Subject: Part 373 HW/APC Permit Modification to revise the April 20, 2004 approval to install agitators on tanks 335-300, 400 & 500

Reference: DEC #4-0103-16/16-0  
373 HW/APC Permit  
Norlite Corporation  
Cohoes(C), Albany County

Re: Part 373 HW/APC Permit Modification approval dated April 20, 2004 to  
install agitators on tanks 335-300, 400, 500 & 600.

NOZZLE UPGRADE DETAIL  
SCALE: NONE

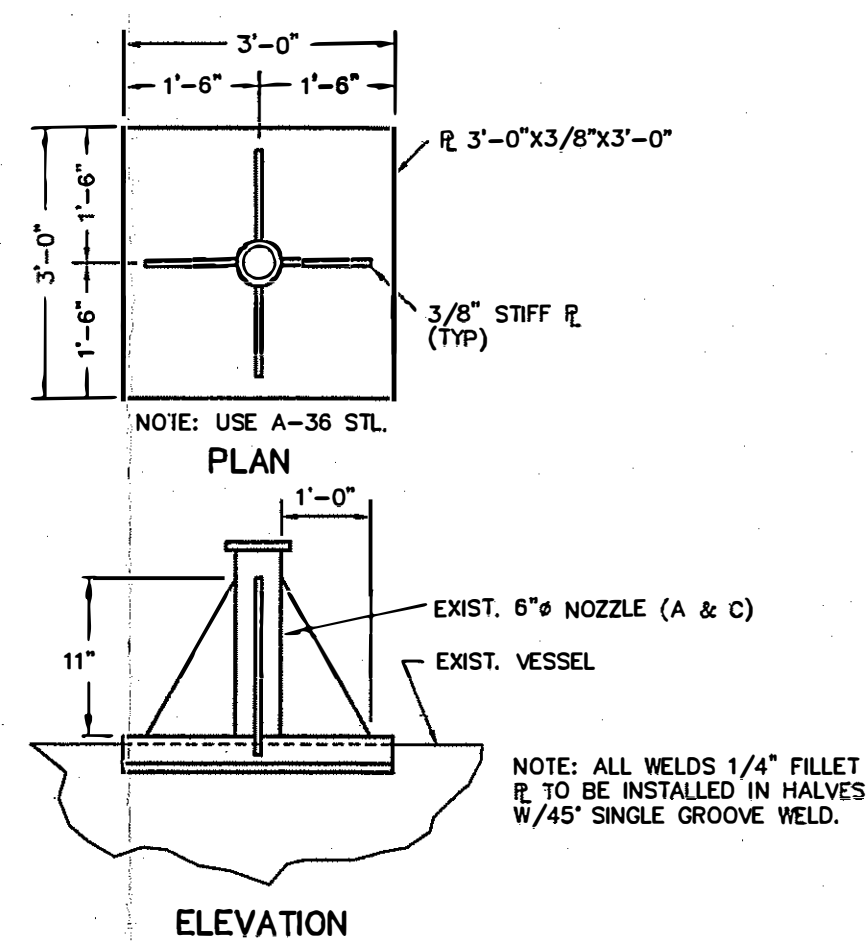
The Department has received & reviewed your June 30, 2004 letter requesting to revise the permit modification granted on April 20, 2004 to install agitators on tanks 335-300, 400 & 500. Norlite is proposing to reduce the nozzle projection from 24" to 12" and to install two 6" nozzles (H & I) on tanks 335-300, 400 & 500. The Department is hereby revising the permit modification granted on April 20, 2004 and re-issuing the approval letter with the following conditions:

Additionally, Norlite has revised drawing number NY003-5433 to show a reduced nozzle projection for the agitators, (A&C) to 12" instead of 24", added a new 6" nozzle (H) for the level transmitters and added a new 6" nozzle (I) for the unloading area fill line/recirculation line from the kiln burners. This drawing was included in the "Technical Evaluation/Selection Report for LGF Blending Mixers" which was submitted to the Department on February 11, 2004. The changes to the drawing have been discussed with Mr. Parag Amin and he indicated submitting the revised drawing would suffice and Norlite would not be required to resubmit the complete report. The revised drawing is enclosed so the Department can insert it into the report.

| FUTURE NOZZLE INSTALLATION MODIFICATIONS |          |            |   |
|--|----------|------------|---|
| A  | 6"       | 12"        | AGITATOR  |
| C  | 6"       | 12"        | AGITATOR  |
